END OF LIFE WARNING

Document ref:	PCN140203A v1.0
Issued:	03 Feb 14
Authorised:	JPG

GTXO-92

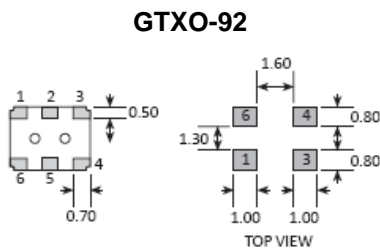
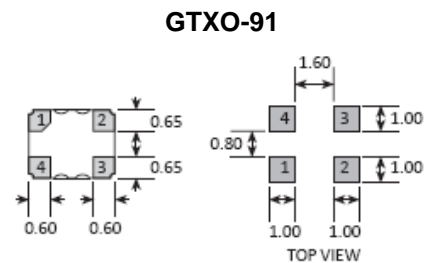
Our 4-pad GTXO-91 is a drop-in replacement for GTXO-92, with identical electrical connections to the four corner pads. (The GTXO-92 has 6-pads, with pads 2 and 5 not connected).

PAD	CONNECTION
1	Ground or Freq adjustment
2	Not connected
3	Ground
4	Output
5	Not connected
6	Supply

PAD	CONNECTION
1	Ground or Freq adjustment
2	Ground
3	Output
4	Supply
